Volume II

In response to Comment I006-309, an analysis was conducted of interim terminal stations for the F-B LGA. The analysis follows below. Although the Technical Appendix is new text, for readability, Technical Appendix 2-I has not been underlined.

Appendix 2-I: Interim Terminal Station

Appendix 3.19-A
Figure 3
Planned and Potential Projects and Plans
Shafter - Bakersfield

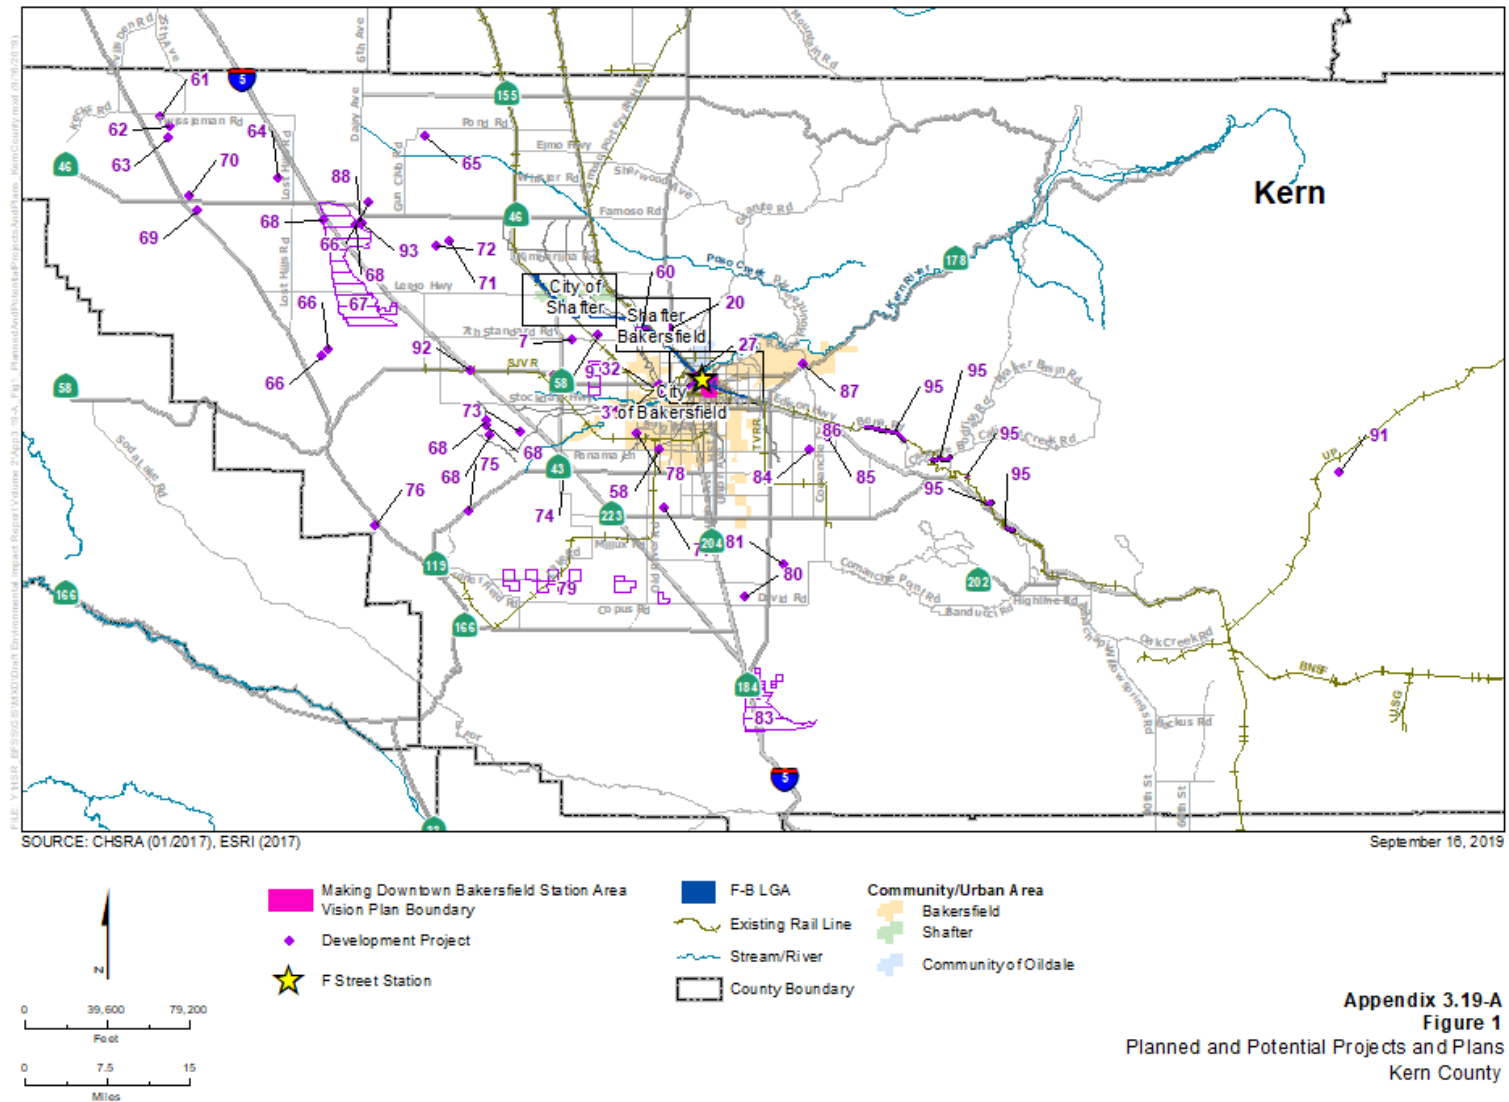
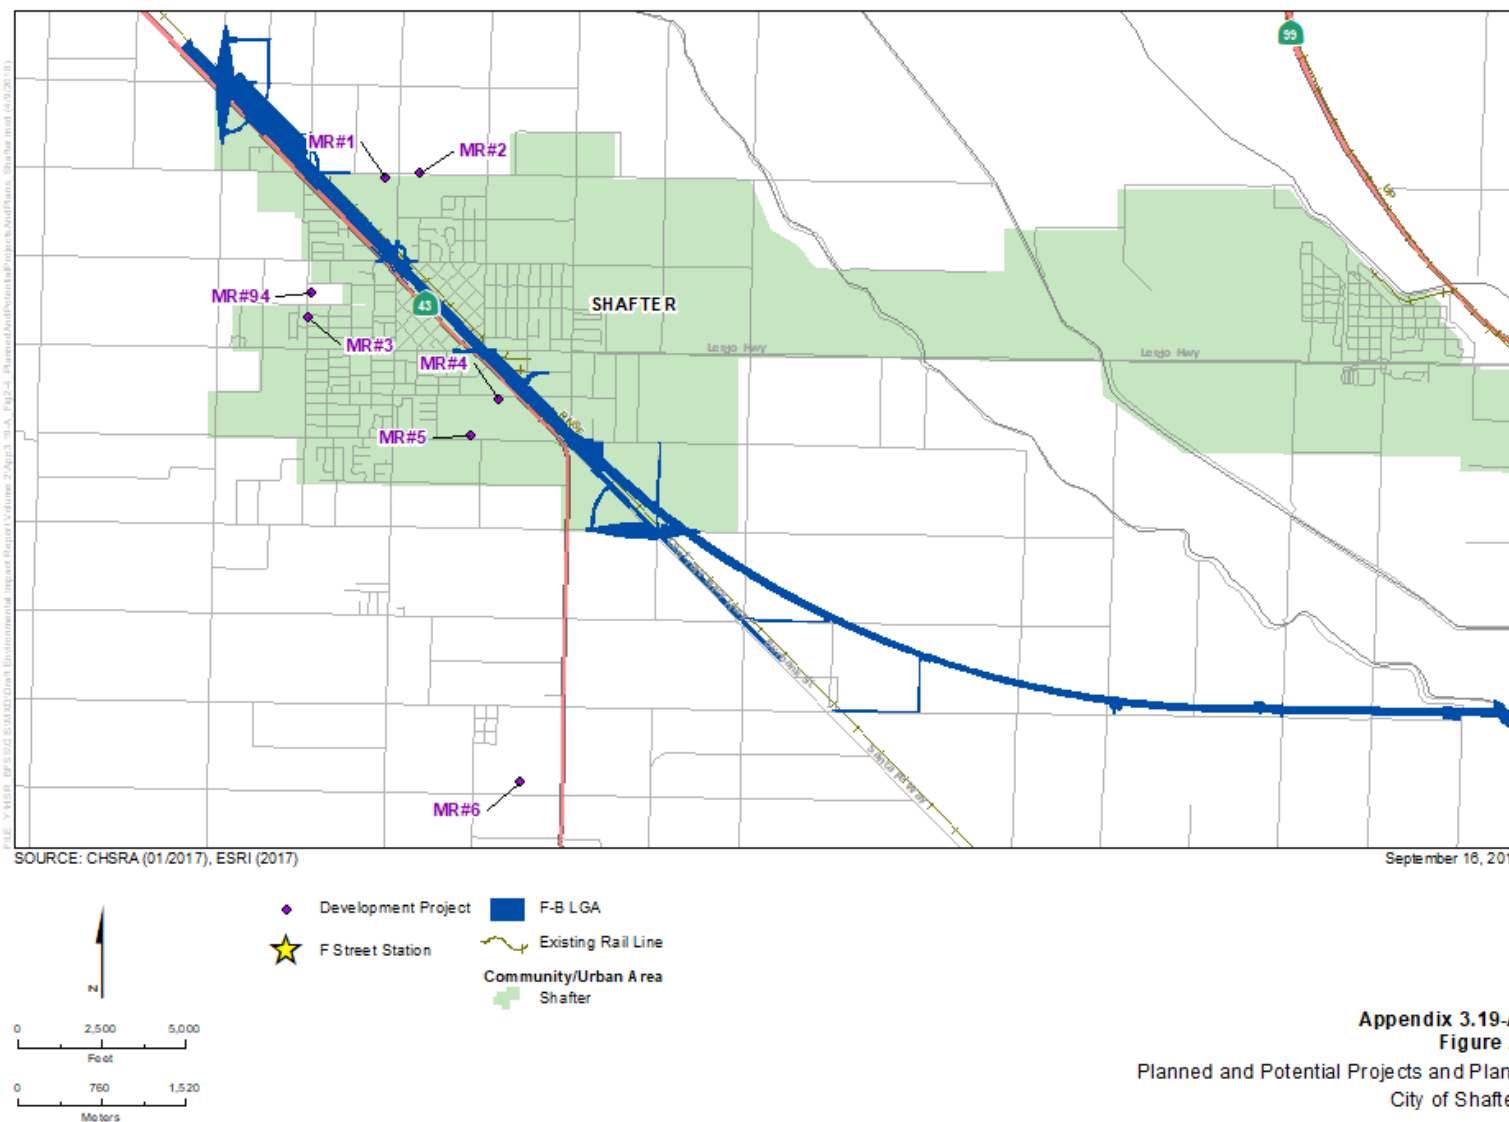
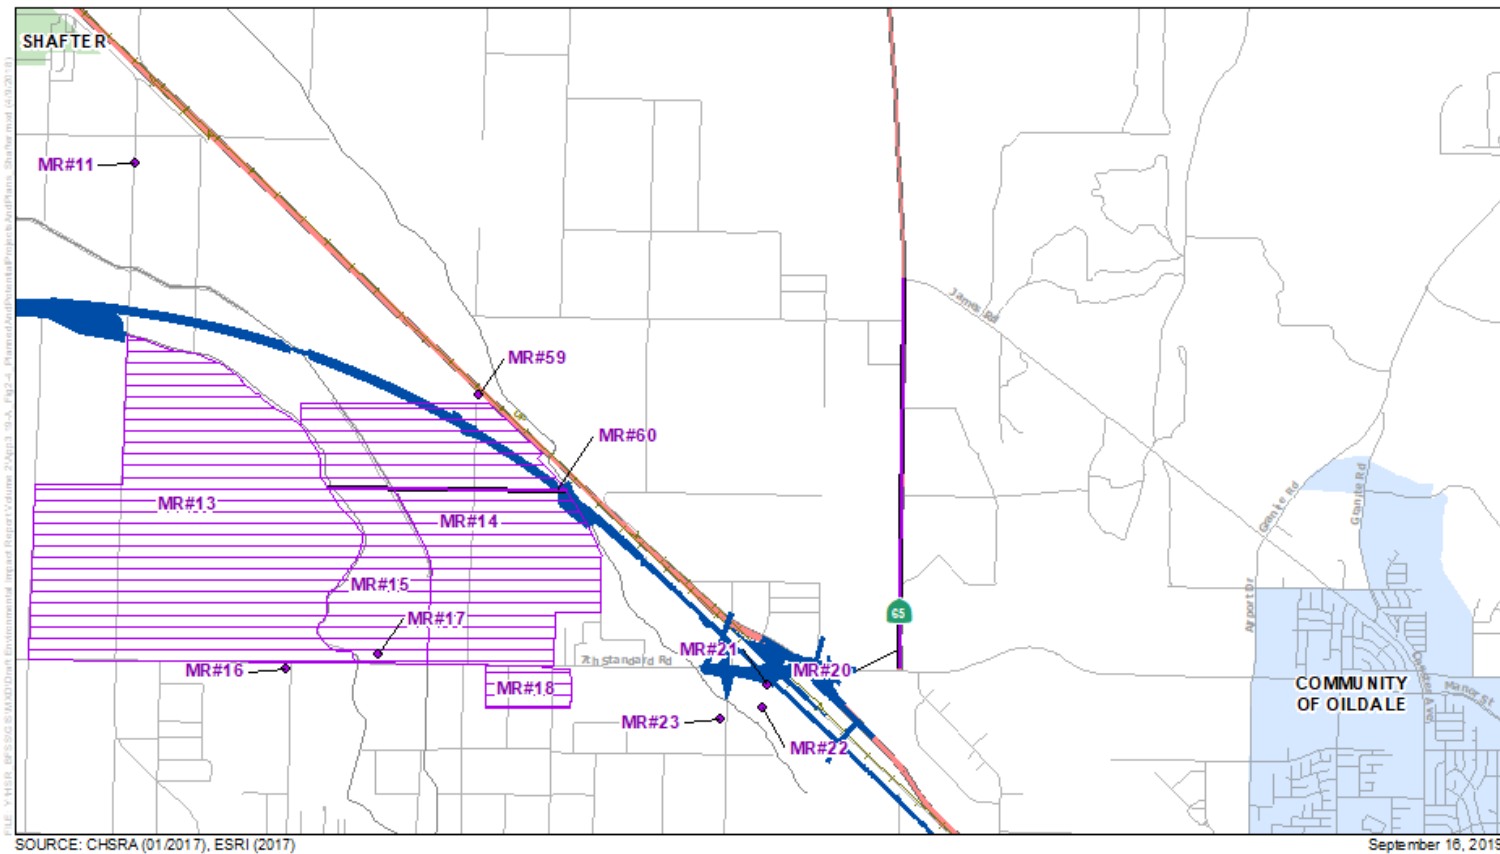
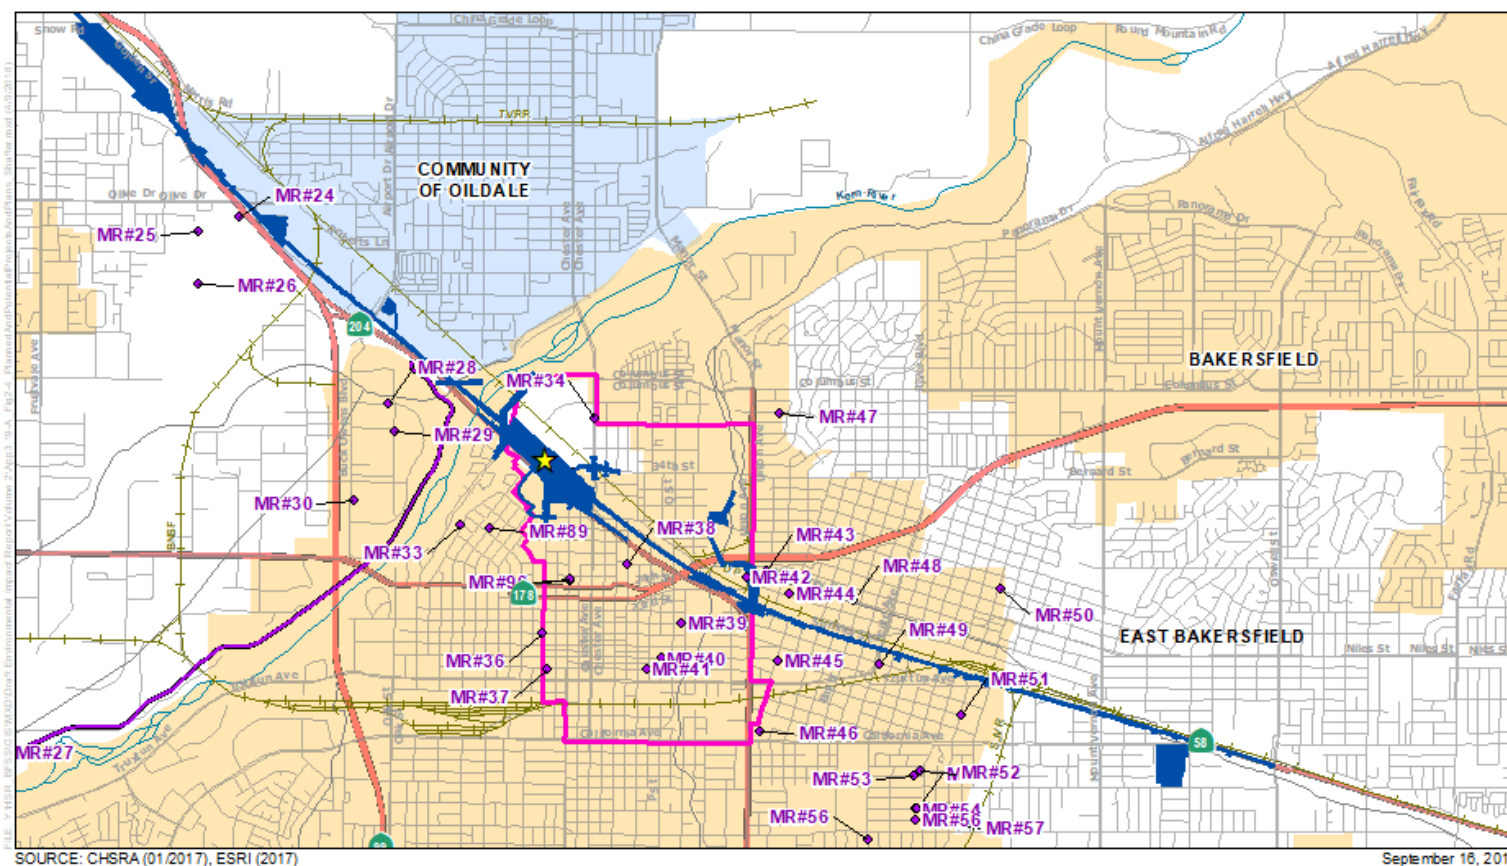
Appendix 3.19-A Figures 1-4 were also factually corrected to include the Making Downtown Bakersfield Station Area Vision Plan boundary; see below.

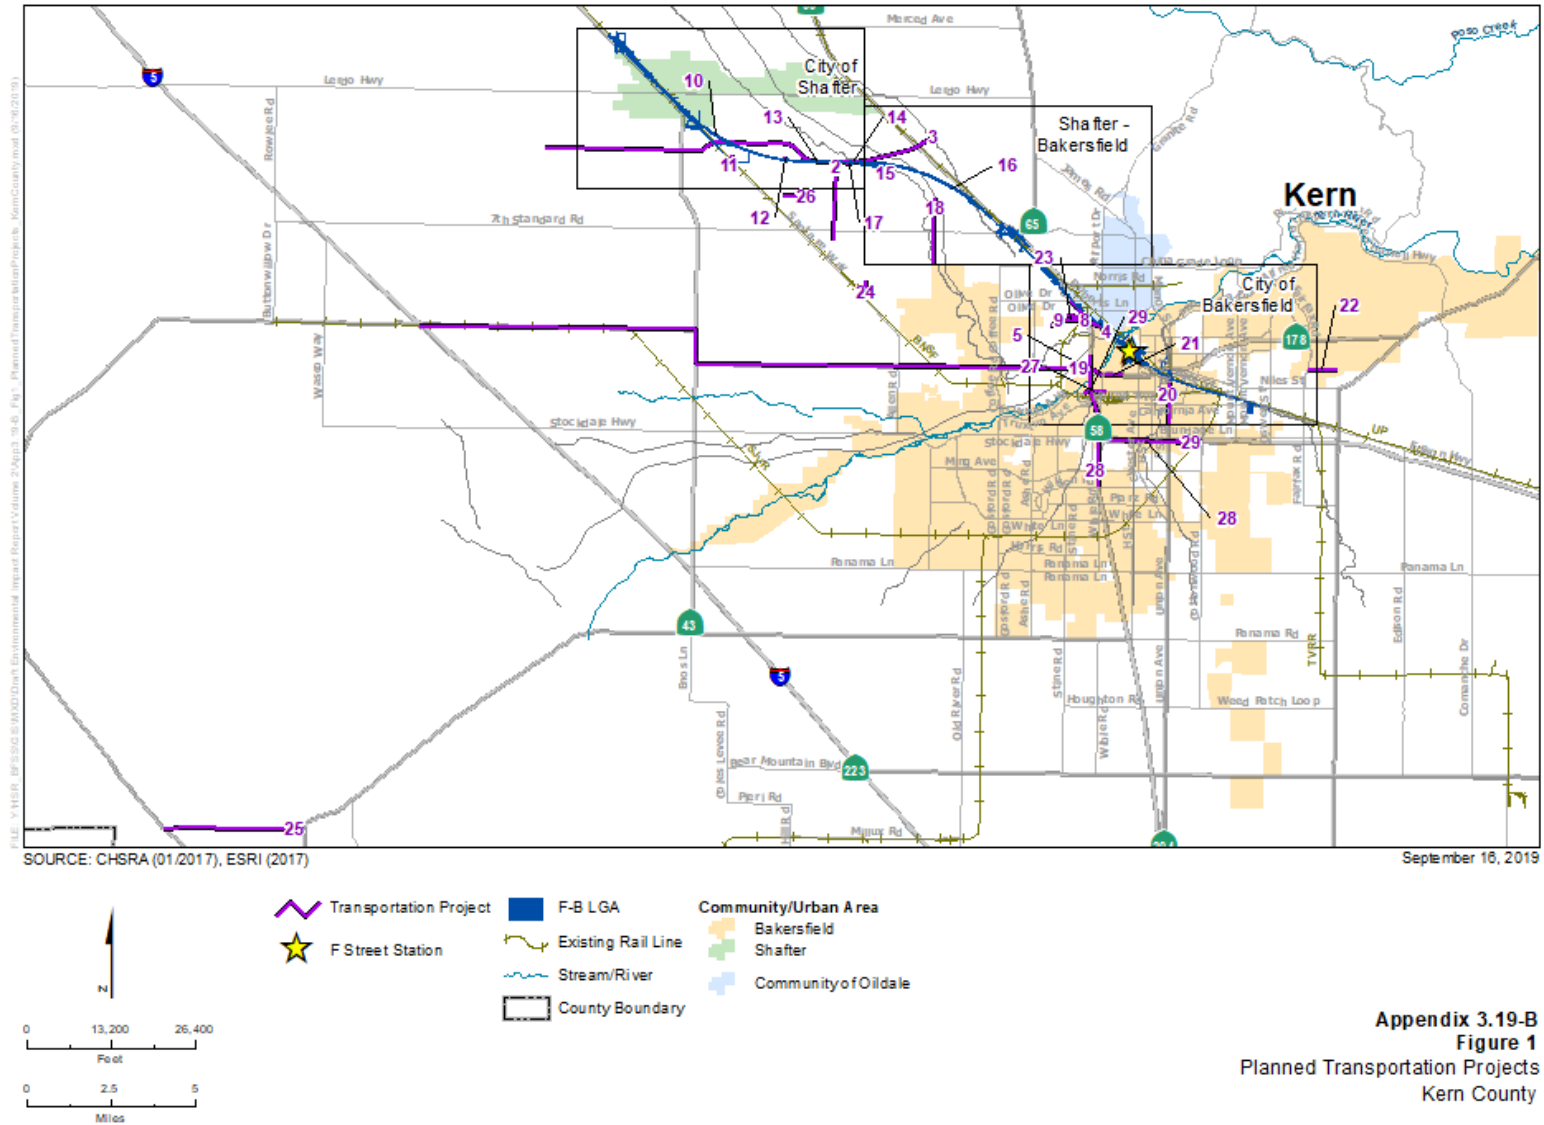
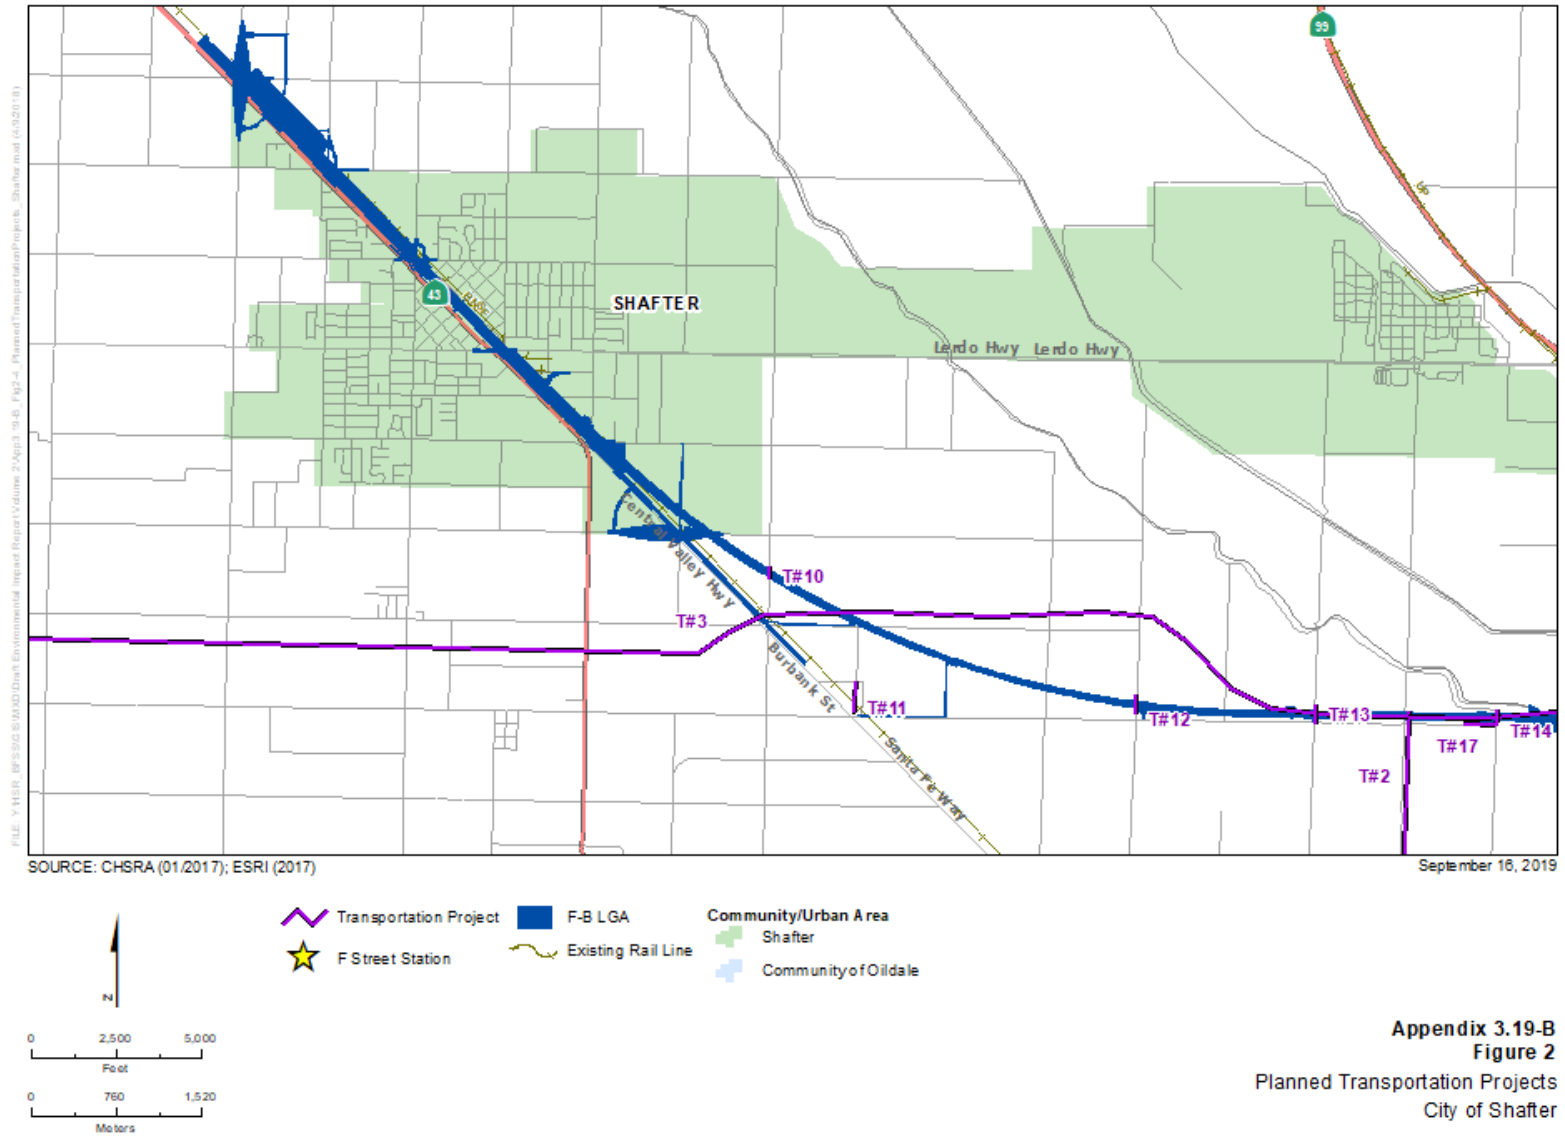
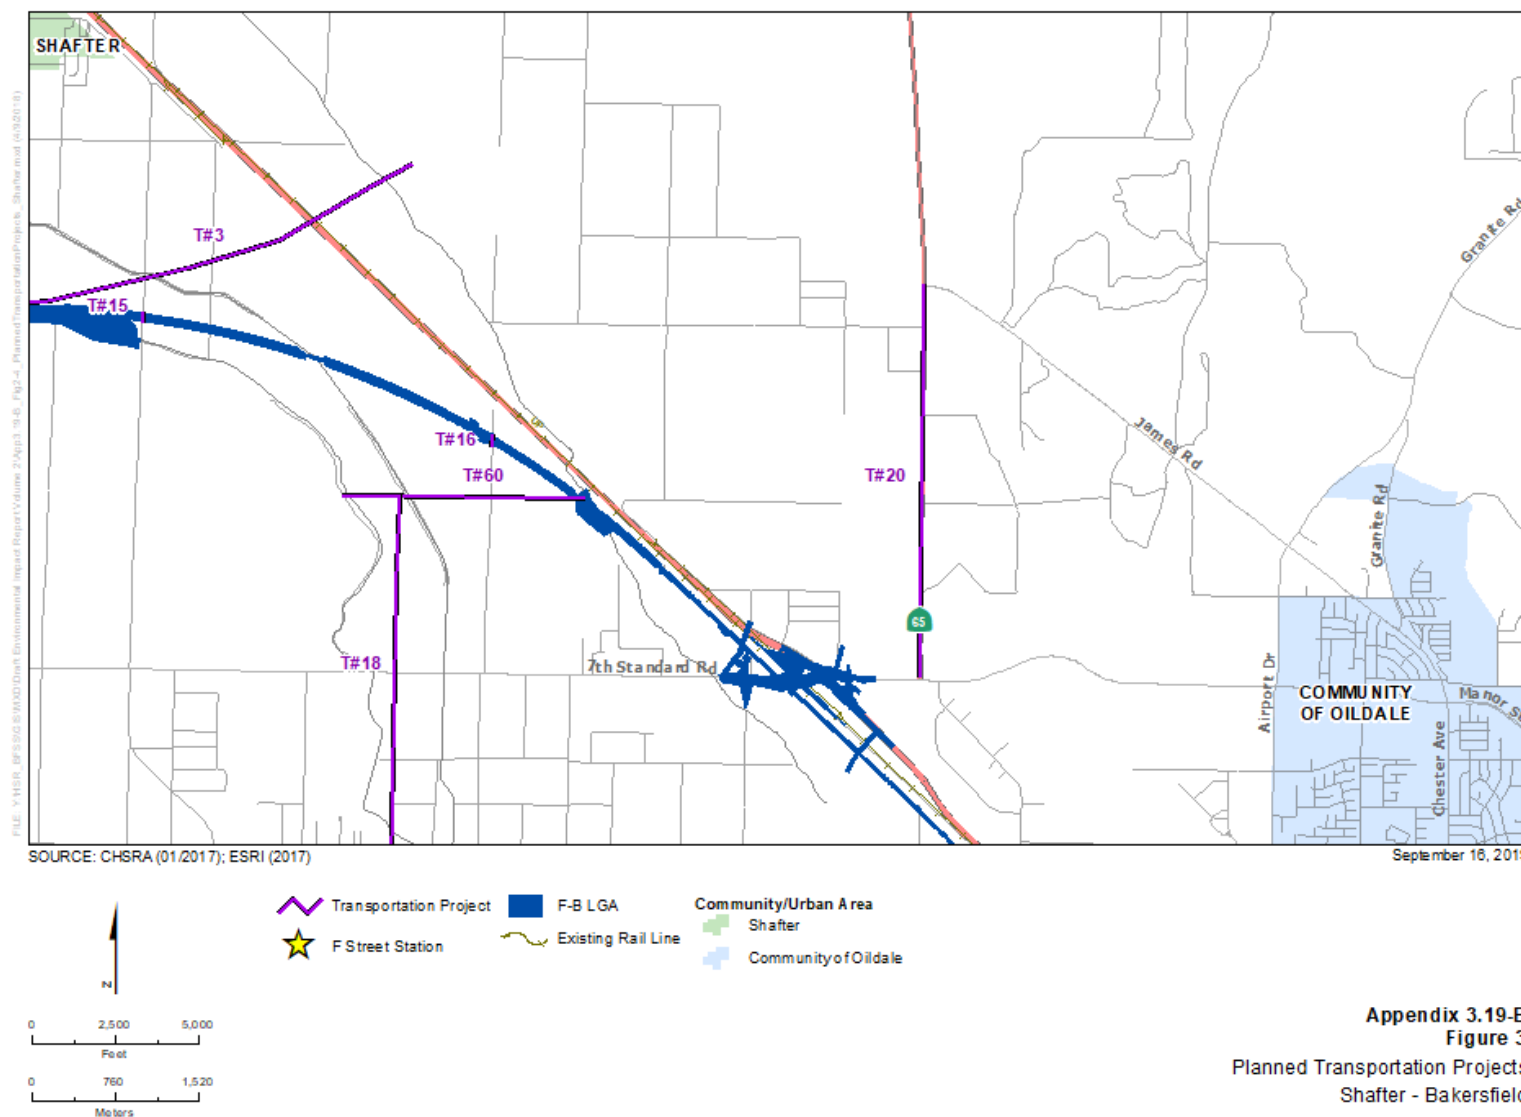
Appendix 3.19-B Figures 1-4 were factually corrected to include the three additional projects in Table B-3, described above, as well as labels for the communities of Oildale and East Bakersfield; see below.
